Martin Place Station Precinct South Site

State Significant
Development Assessment
(SSD 9326)

July 2019

Figure 15 | Eastern elevation with key podium and tower elements highlighted (Source: Applicant's RtS)

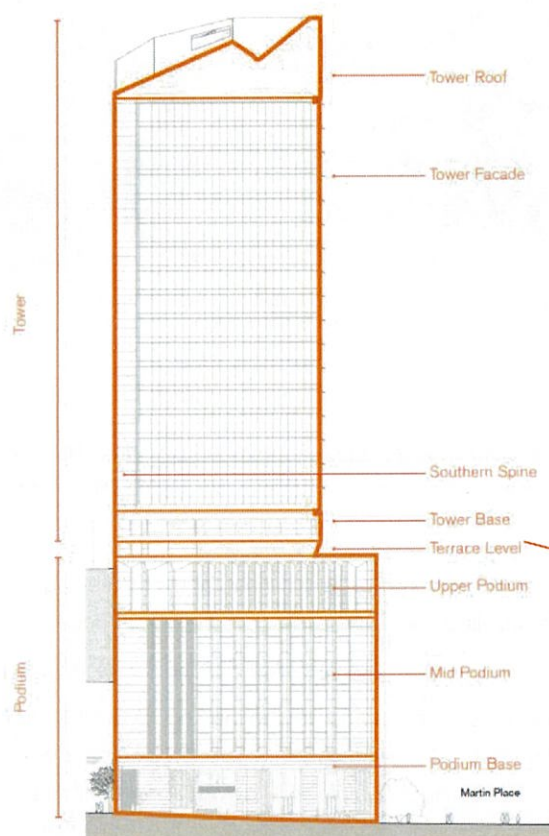
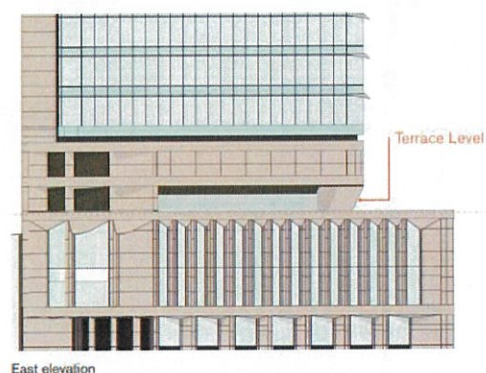
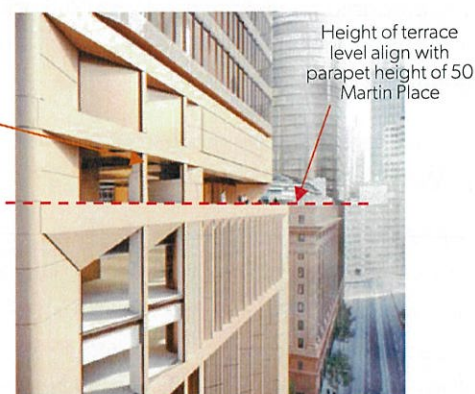
The proposal has no setback between the podium and tower along Elizabeth Street and Castlereagh Street (**Figure 15**). A terrace on Level 9 of the podium with a deep setback beneath the tower articulates the tower as a discrete form above the podium (**Figures 16 and 17**) and also responds to the parapet height of 50 Martin Place.

Figure 18 | Extracts from Council's objection requesting 8 m by 8 m building returns to be provided at the southern corners (Left: plan view, Right: Castlereagh Street Elevation) (Source: Council's submission to Amending Concept SSD 9347)

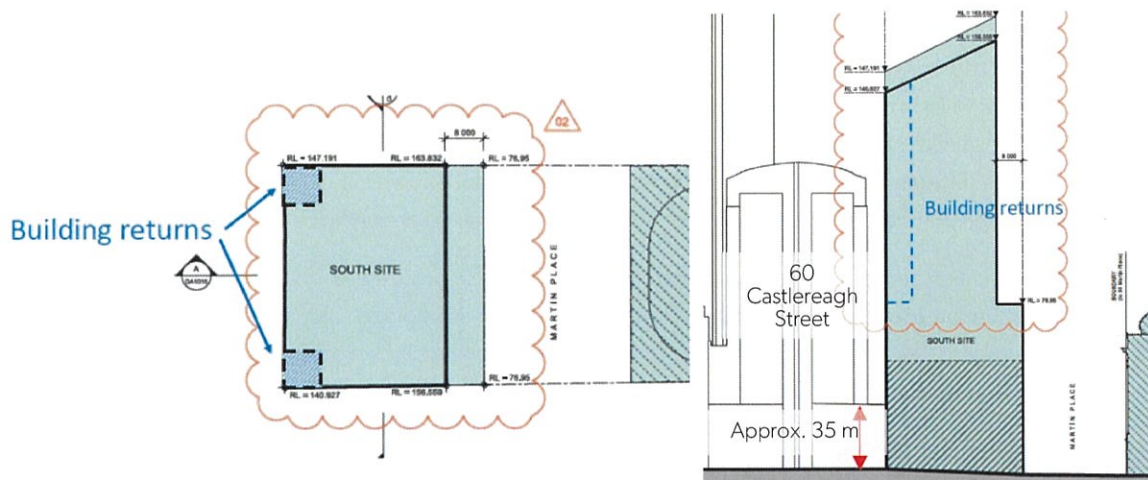
Council's submission requested an 8 m tower setback be applied to the Elizabeth Street and Castlereagh Street frontage of the site. Council considered an 8 m tower setback would allow the building to integrate better with the character of Central Sydney and Martin Place.

The Department notes Council's request relates to controls in the Sydney DCP, which seek a minimum weighted average setback of 8 m above the podium. As was the case with Council's previous submission to the Amending Concept SSD 9347, Council recommended that, in lieu of providing the Sydney DCP tower setbacks, building returns of 8 m by 8 m, should be incorporated into the south-east and south-west corners of the tower as a transition to adjoining property to the south (60 Castlereagh Street) above the podium height (**Figure 18**).

The Department agrees with the recommendations of the DRP. The Department notes the introduction of building returns or similar will not provide an acceptable transition of built form to the adjoining development to the south, which has a substantially lower podium height of approximately 25 m and tower setback of 5 m and 5.5 m to the street frontages (**Figure 23**). The Department accepts the proposed vertical expression of the south corners provides a suitable transition to the adjoining site to the south as well as presentation to the street frontages.

Figure 22 | Part elevation (Elizabeth Street) showing corner treatment with vertical re-entrant (Source: Applicant's RtS)

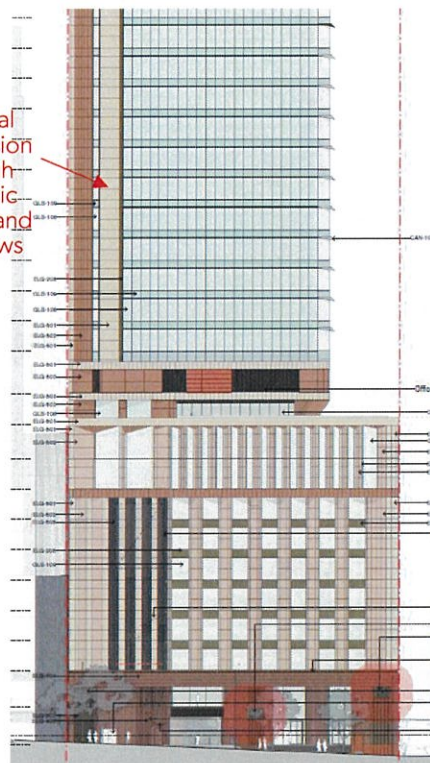
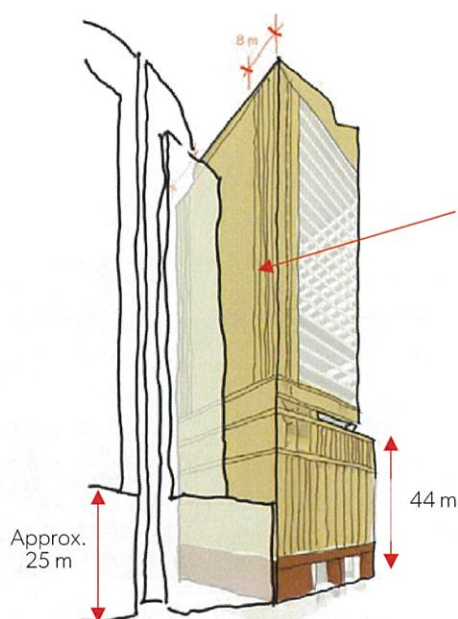
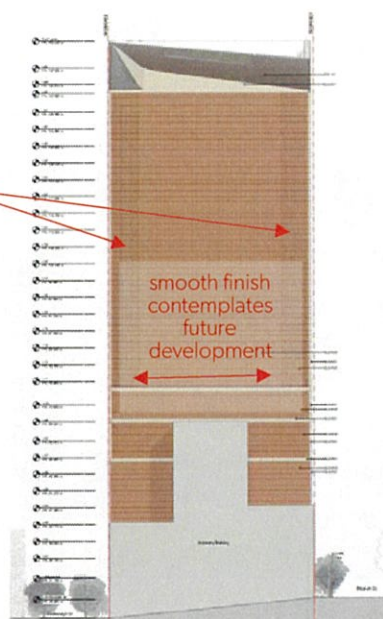
The DRP supported the Applicant's revised architectural expression of the south-east and south-west corners comprising curved corners above the podium height and a vertical re-entrant expressed for the full height of the building (**Figures 21 and 22**). The elevation uses ceramic panels with angled patterning for the first 8 m, then a smooth finish in the middle to anticipate future development (**Figures 23 and 24**).

Figure 25 | Plan of increased solar access to Hyde Park compared to Concept Approval envelope – taken at 1:45pm as an example (Source: Applicant's RtS)

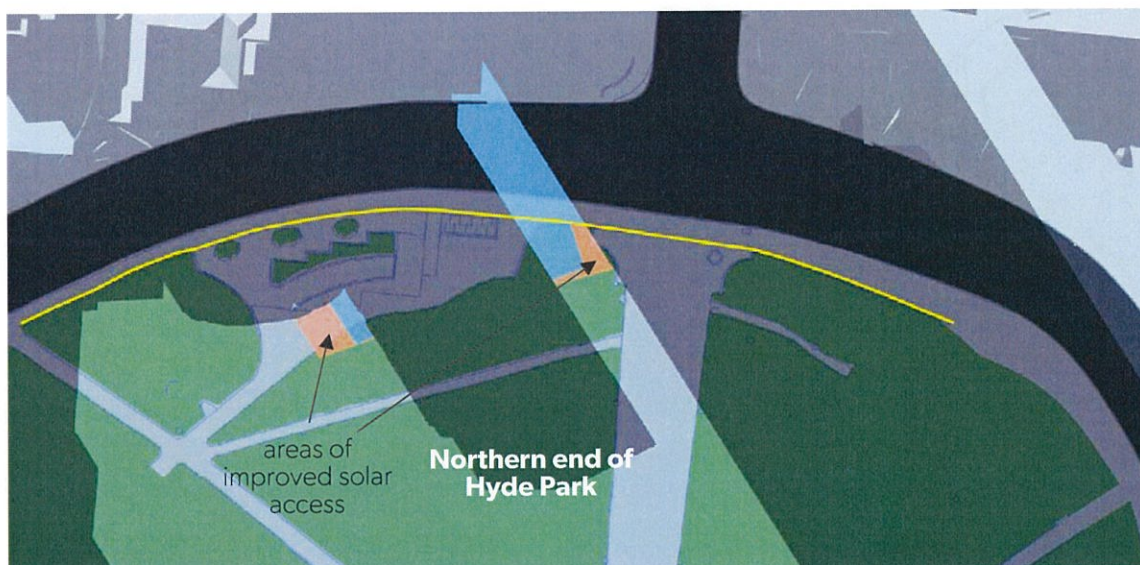
The proposed built form meets the requirement of Condition B2(a) above. Shadow diagrams within the Applicant's RtS demonstrate that the proposal reduces shadows cast onto Hyde Park during 12noon and 2pm in midwinter by a cumulative 171m² (+40%) when compared to the Concept Approval building envelope. A snapshot of this increase, taken at 1:45pm on 21 June as an example, is provided at (**Figure 25**). There are varying amounts of increase measured in 15 minute intervals within the Applicant's RtS, with the most benefit arising between 1:30 pm and 2 pm.

The Department notes that the additional solar access relates to the northern-most end of Hyde Park around pedestrian entry pathways. Additional solar access at these areas of the park in midwinter will have broad public benefit.

The proposal's improved solar access to Hyde Park when compared to the approved building envelope was achieved by the proposed building being 12 m lower than the approved building envelope and also through the refinement of the design of the roof forms in response to the DRP's advice.

Figure 27 | Perspective of proposal and its relationship with 50 Martin Place (Source: Applicant’s RtS)

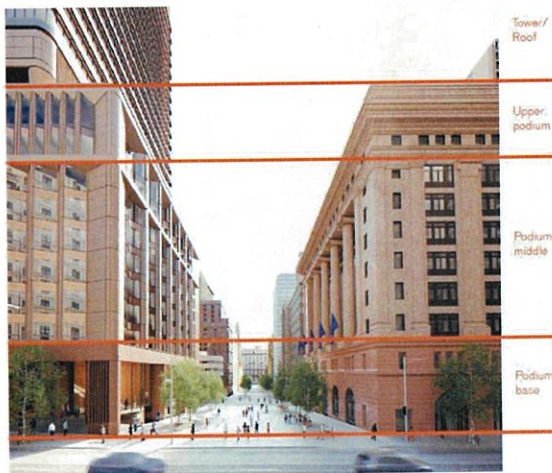
The proposal seeks to provide a contemporary interpretation of the detailing and proportions of 50 Martin Place to the north. This includes the grand architectural finishes and detailing on the façades of 50 Martin Place which defines its strong horizontal and vertical expression. The Department notes the proposal relates to the proportions, form, detailing and interface with 50 Martin Place, and in particular:

- the defined base, middle and top building form
- the height datum of the top of podium to match the parapet level
- the vertical scale within the middle portion by columns and infill glazed panels (**Figures 27 and 28**).

The Department accepts the strong hierarchical architectural language of the podium complements the features of 50 Martin Place. The DRP also supports the deep articulation and repetition used for the podium with curved glazing and vertical ceramic elements in response to the grand order aesthetic of 50 Martin Place.
